Architectural Addendum No. 02

project University of Toronto – Dentistry Clinic 2 Renovation

**project/file
no.** 24082 (UofT Project Number: P065-21-050)

Electrical Addendum No. 2

2 ELEVATOR PLAN - LEVEL 1
1 : 50

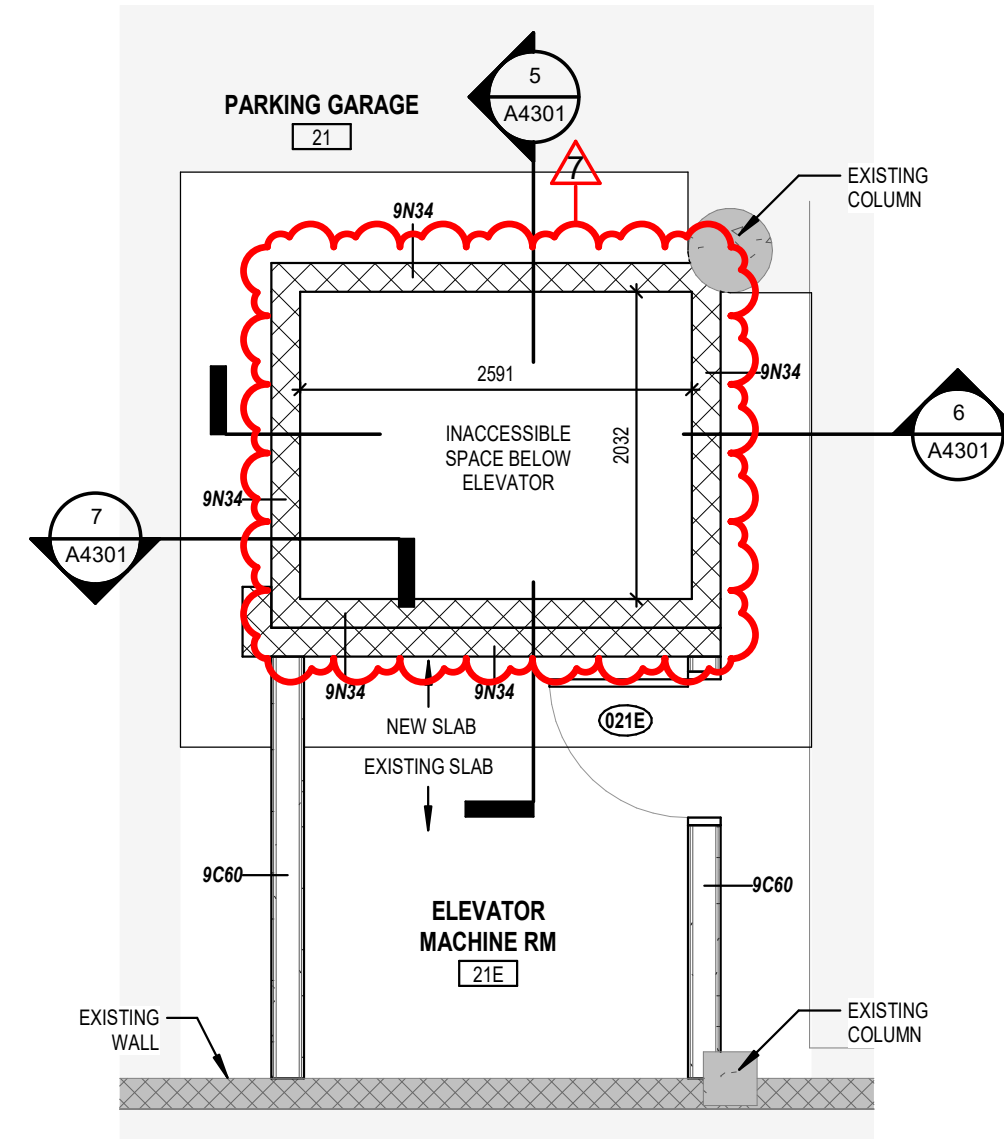
- B1.1.** Drawing 1/A4301 – **ADD** dimensions to elevator hoistway.
- B1.2.** Drawing 2/A4301 – **ADD** dimensions to elevator hoistway.
- B1.3.** Drawing 3/A4301 – **ADD** dimensions to elevator hoistway.
- B1.4.** Drawing 4/A4301 – **ADD** dimensions to elevator hoistway.

6 CLINIC WASHROOMS PLAN
1 : 20

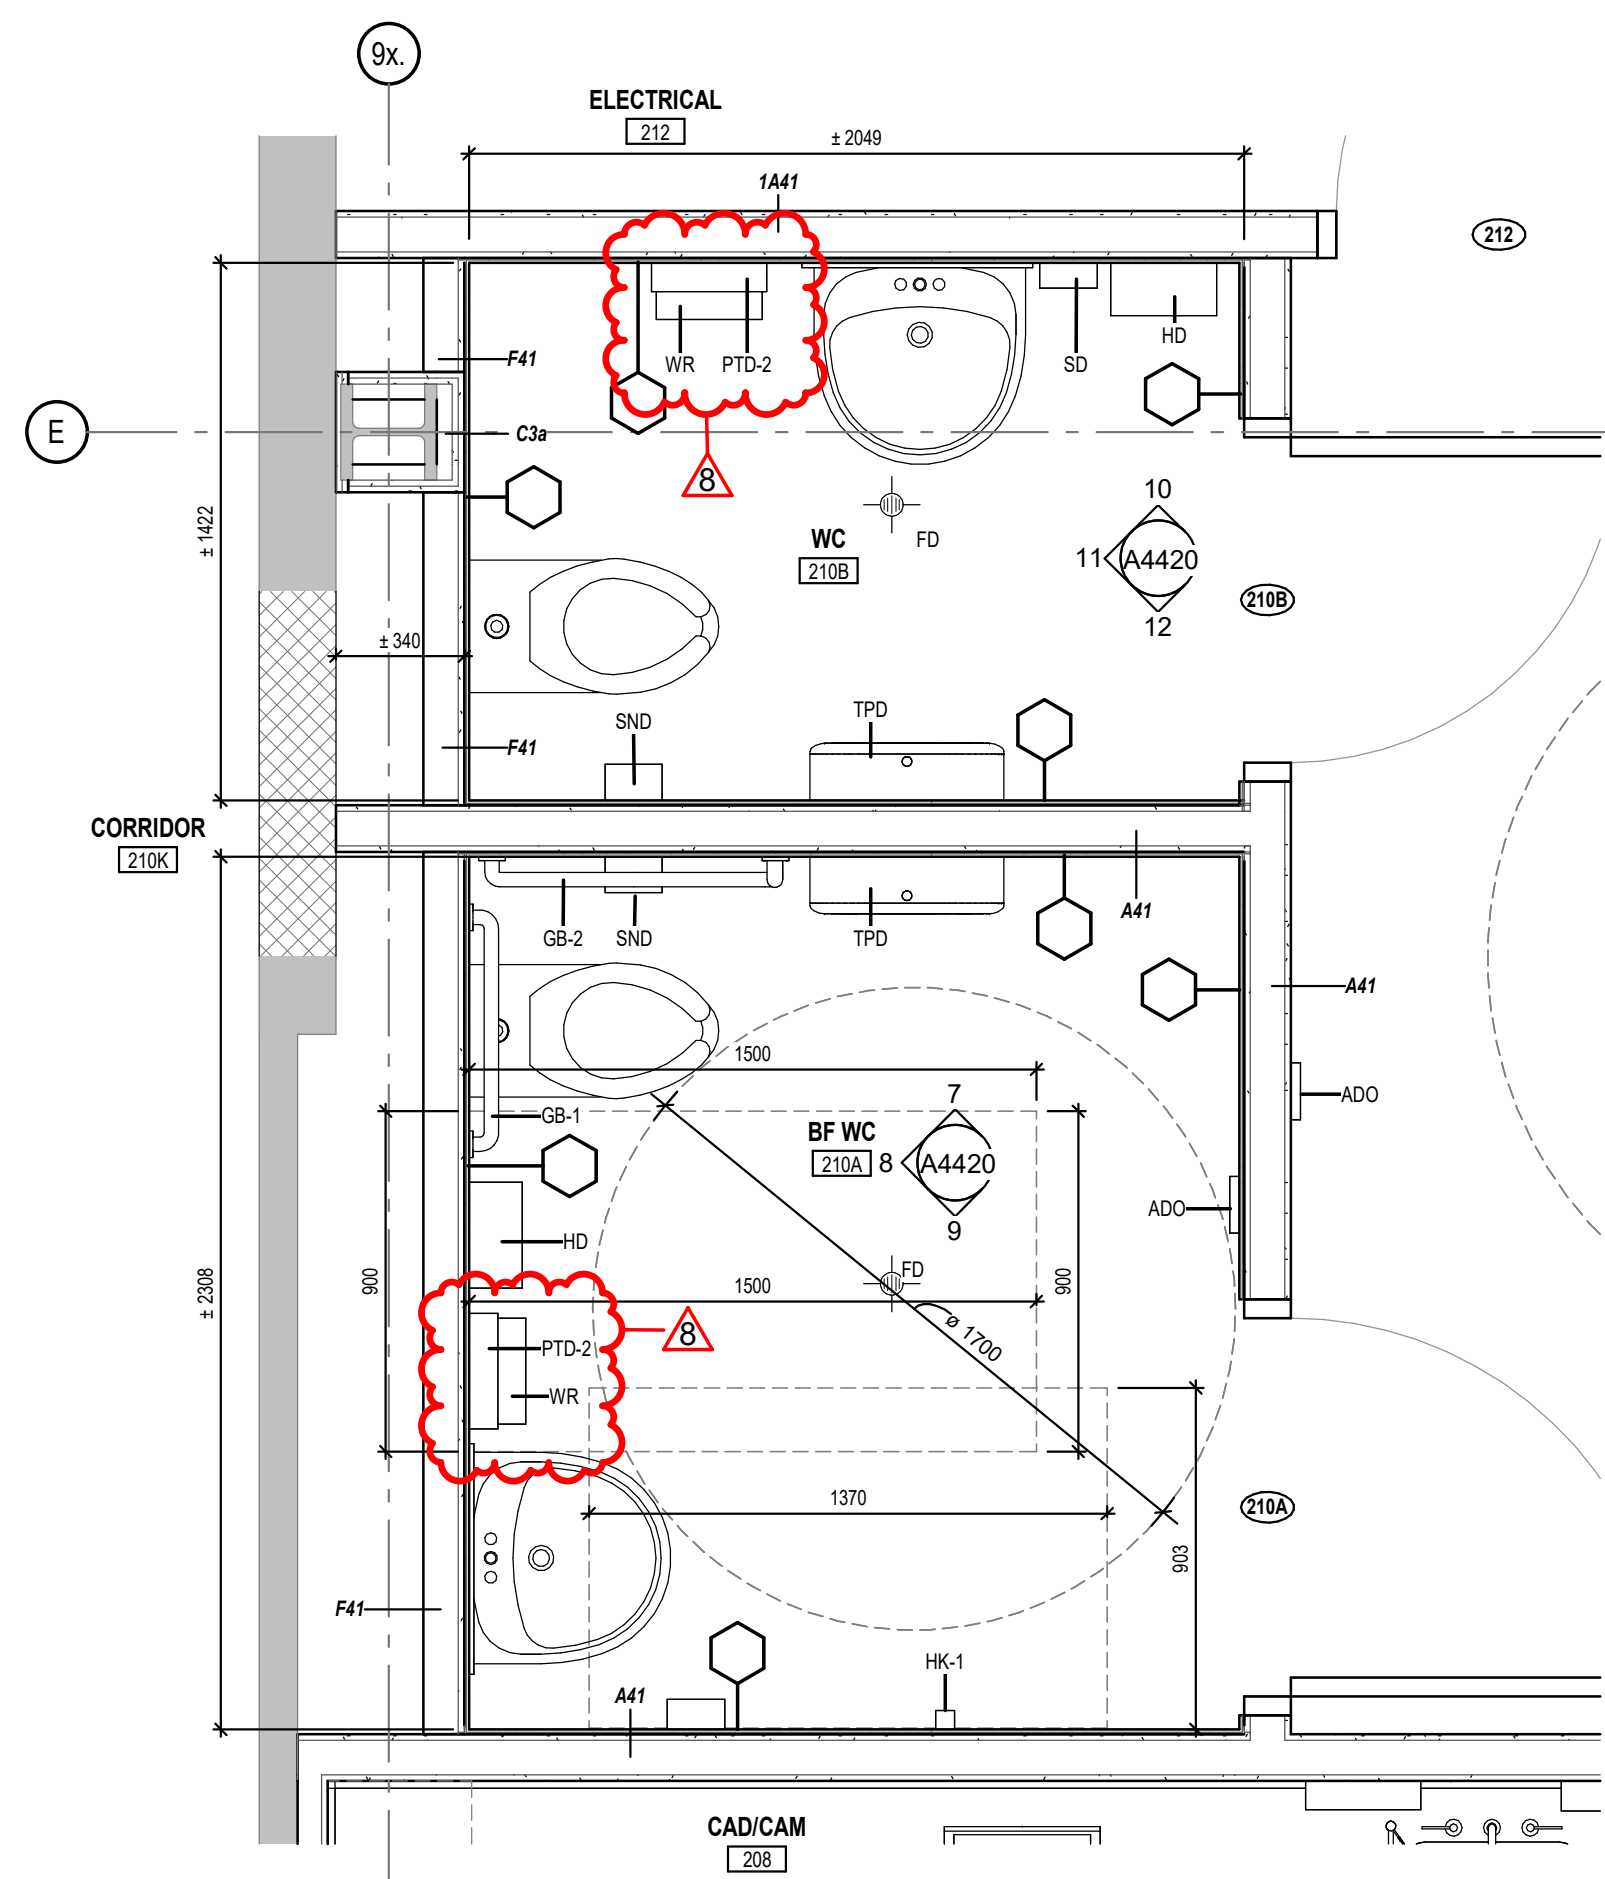
- B2.1.** Drawing 1/A4402 – **REMOVE** duplicate floor drains in WC (210B) and BF WC (210A).
- B2.2.** Drawing 2/A4402 – **REVISE** paper towel dispenser tag from PTD to PTD-1.
- B2.3.** Drawing 7/A4402 – **REVISE** paper towel dispenser tag from PTD to PTD-1.
- B2.4.** Drawing 8/A4402 – **REVISE** paper towel dispenser tag from PTD to PTD-1.
- B2.5.** Drawing 11/A4402 – **REVISE** paper towel dispenser tags from PTD to PTD-1.

SCHEDULE - DOORS AND
SCREENS

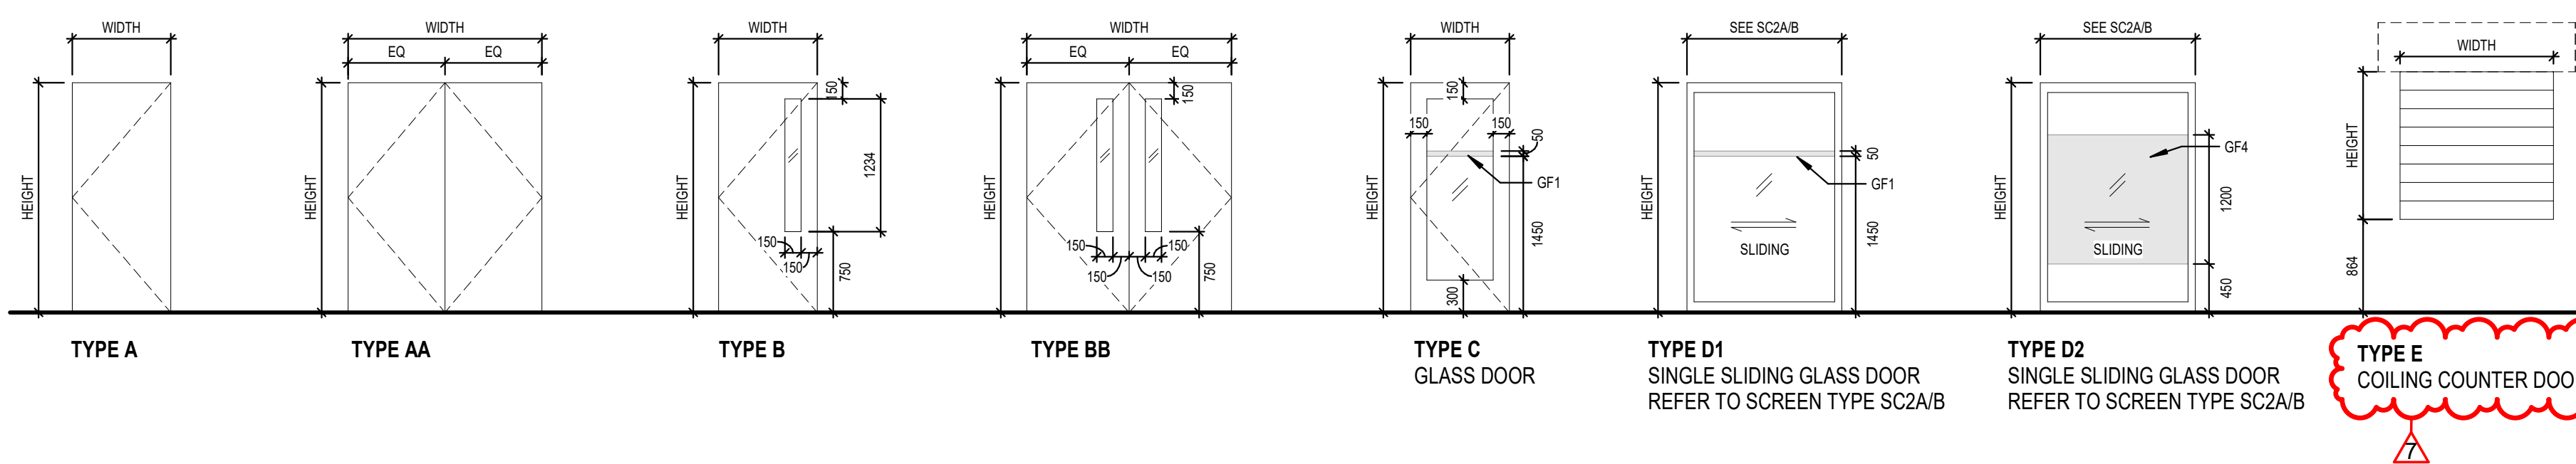
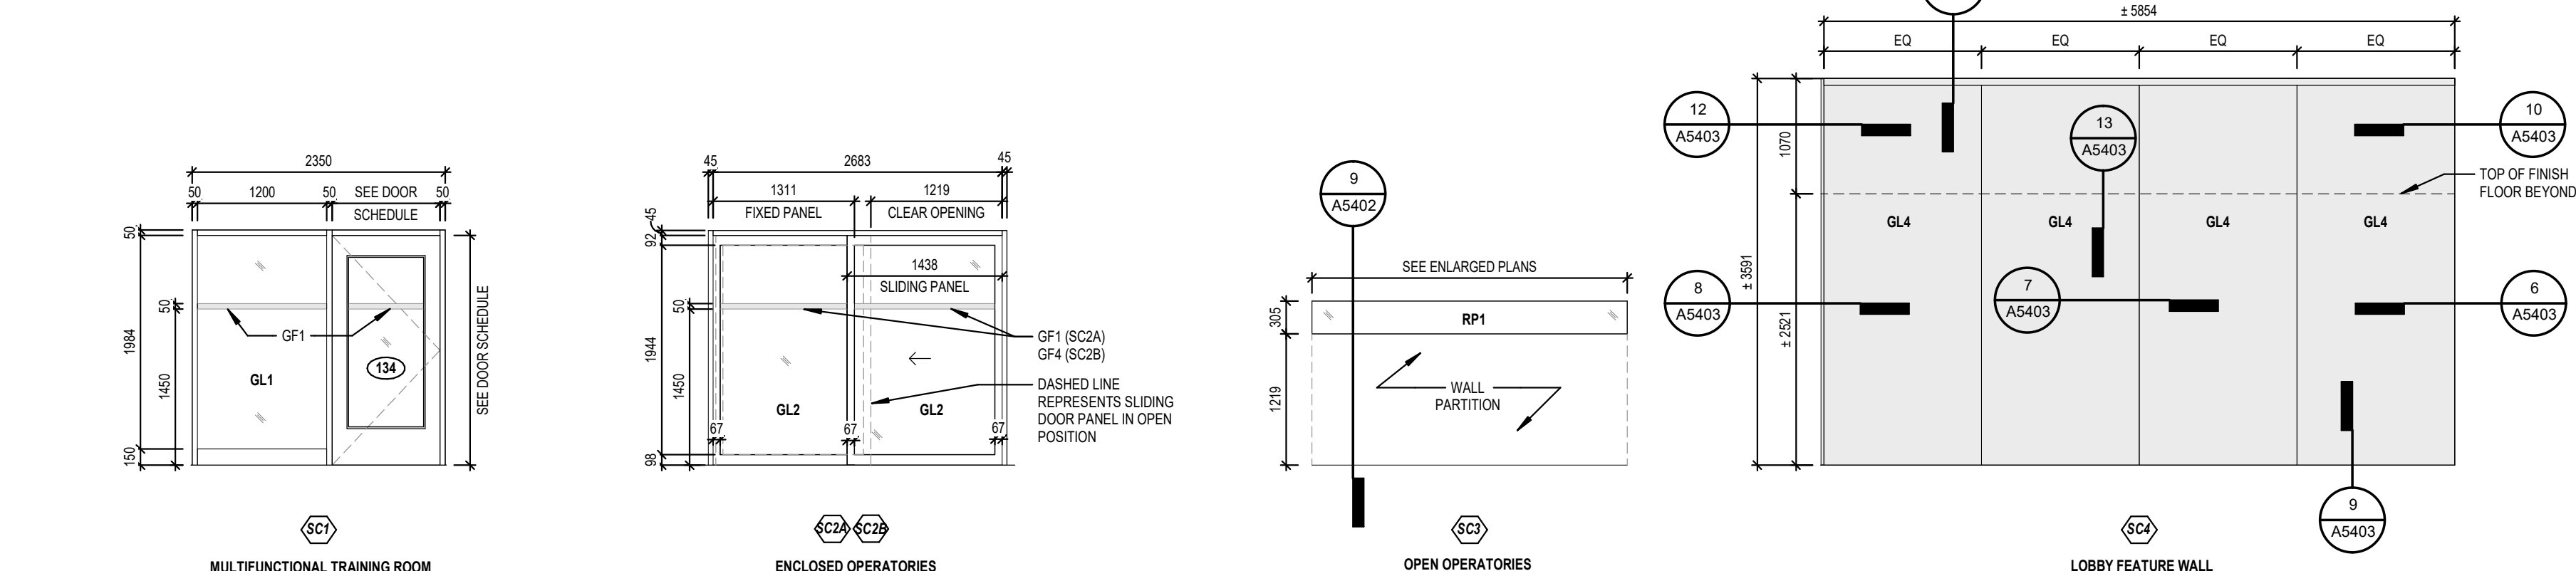
- B5.1.** Door Schedule – **REMOVE** LK integrated electronic lockset & card reader from Electrical (207H), Electrical (212), and Elec Rm (216A).

- B5.2.** Door Schedule – **REVISE** overhead door to coiling counter door in Reception (219OH-1), Reception (219OH-2), and Reception (219OH-3).
- B5.3.** Door Panel Type Elevations – **REVISE** Type E overhead coiling door to coiling counter door.

1.2. E-402: PARTIAL LEVEL 2 - SECURITY & PAGING

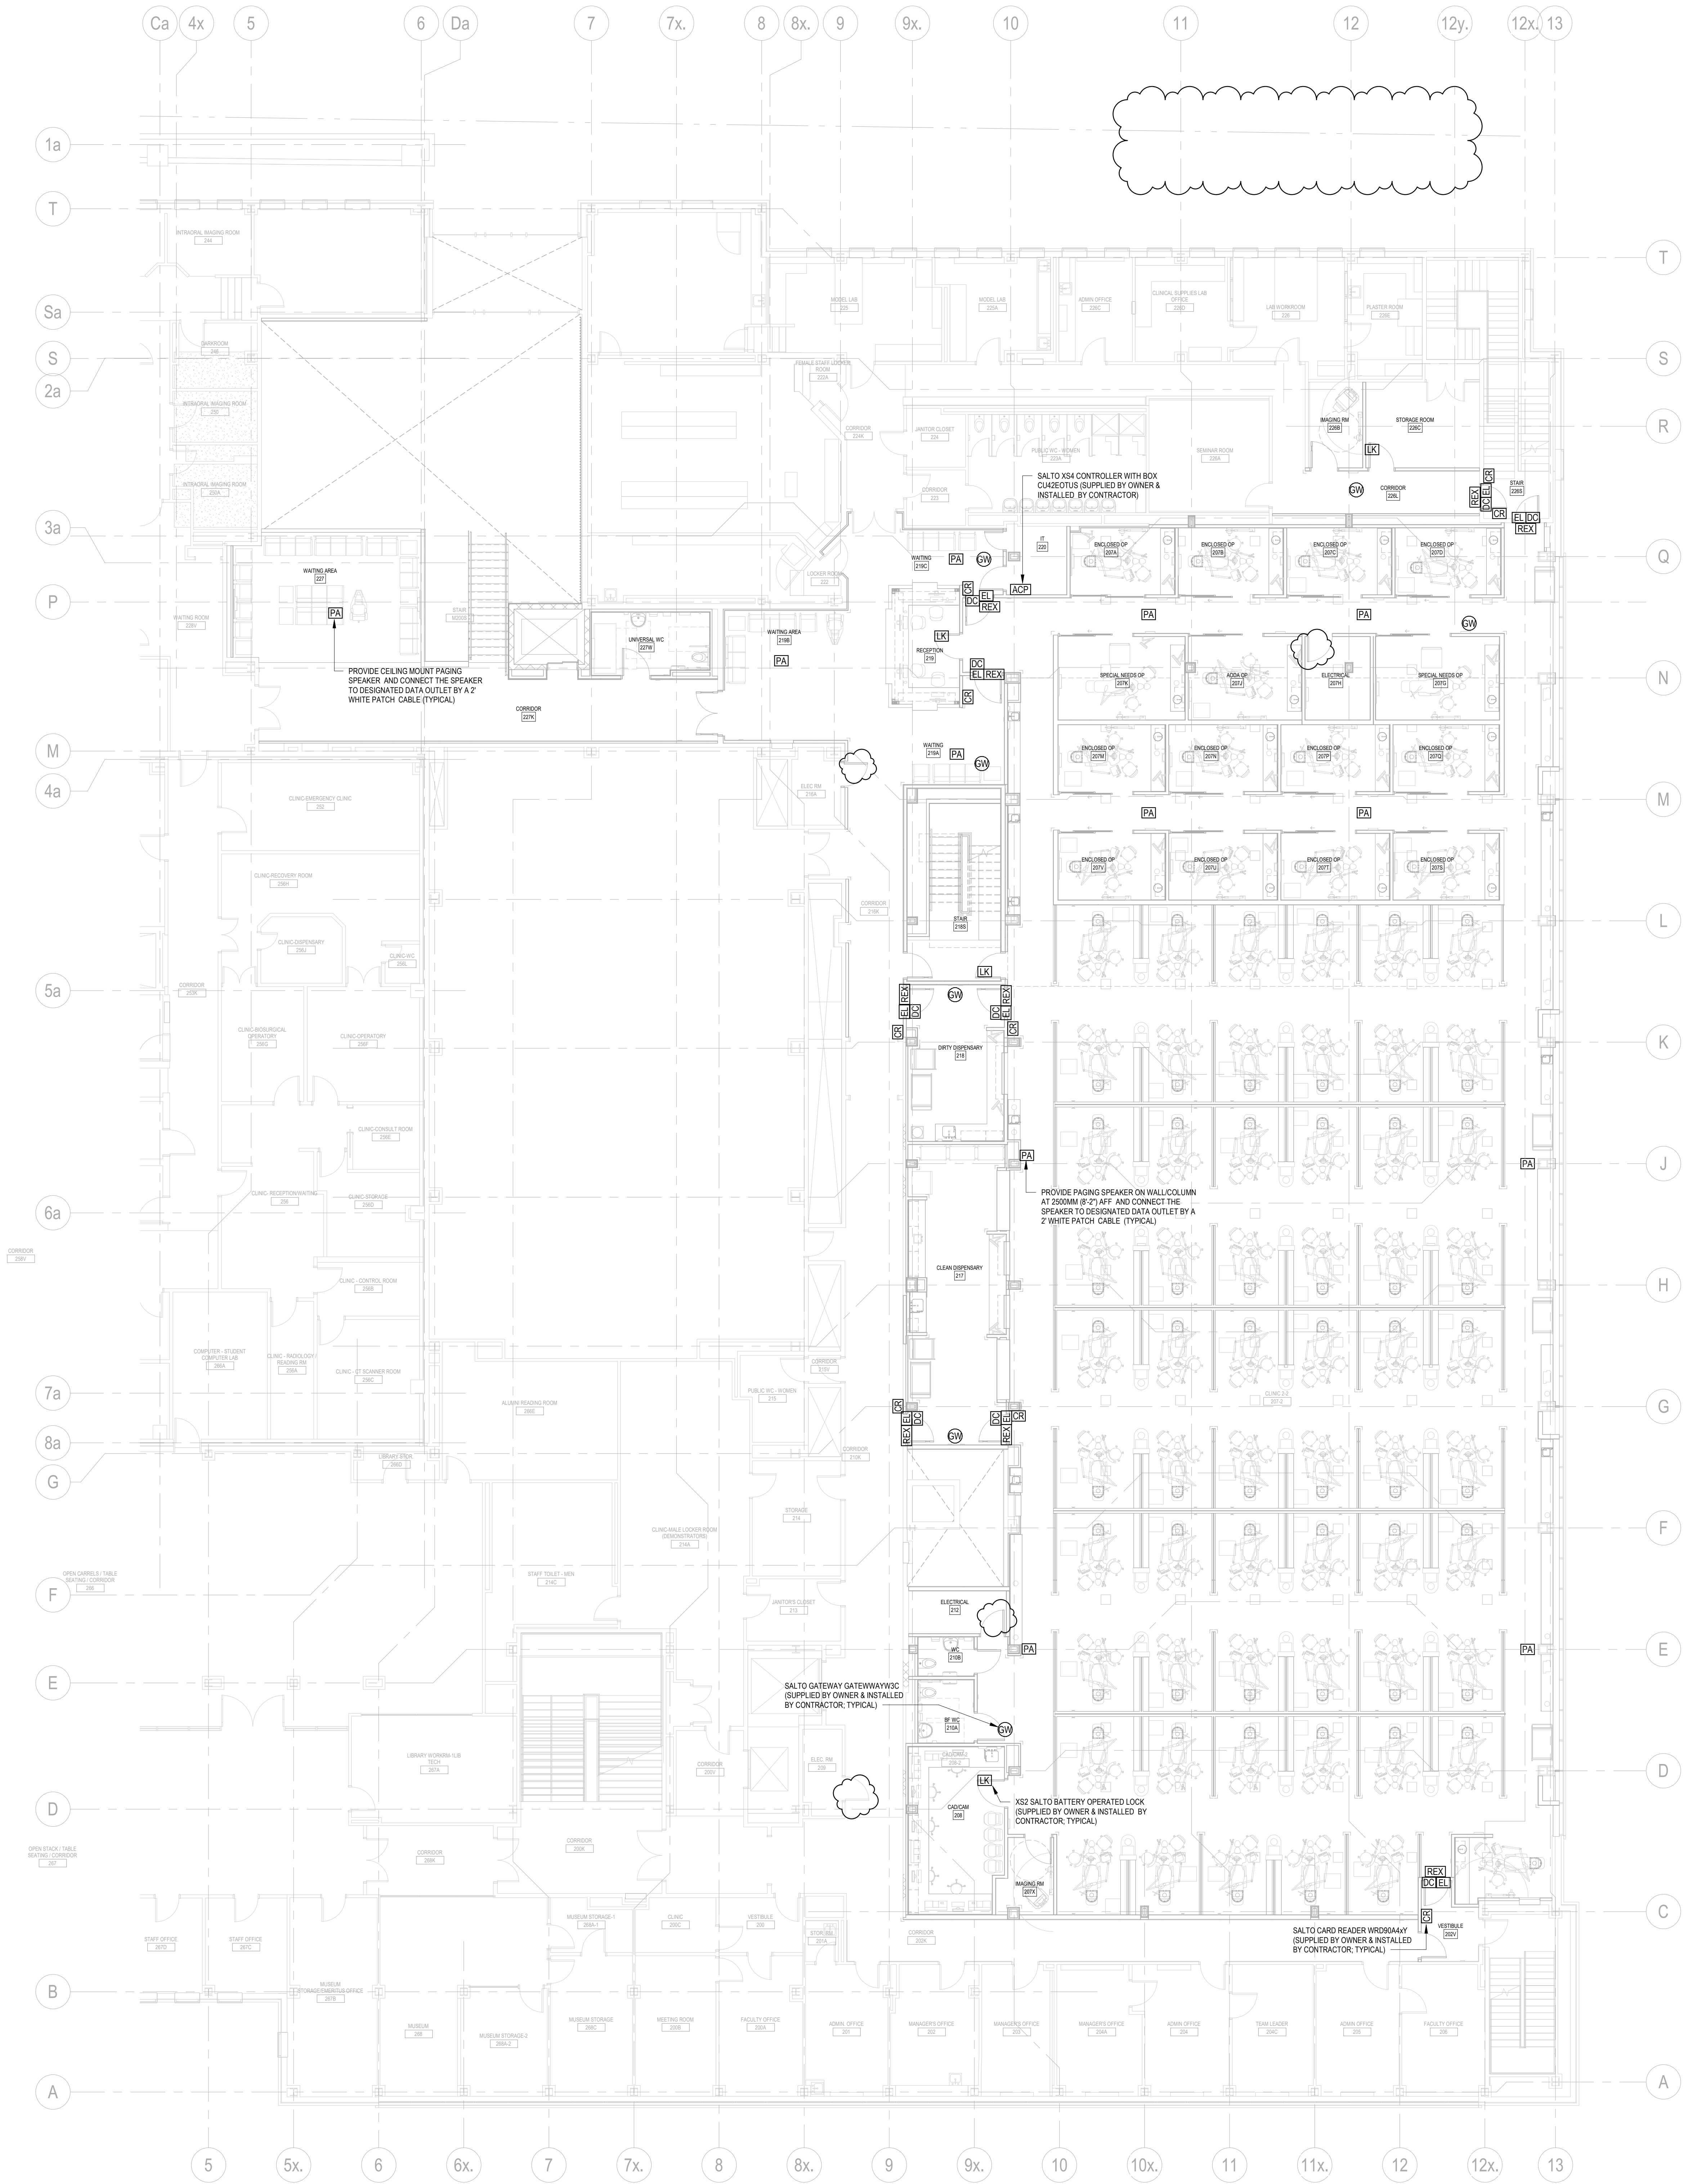
- 1.2.1. Remove Salto locks from the four electrical rooms on L2 altogether: 207H, 216A, 212, and 209.
- 1.2.2. Delete notes for SEPARATE PRICE SCOPE SP-E1.
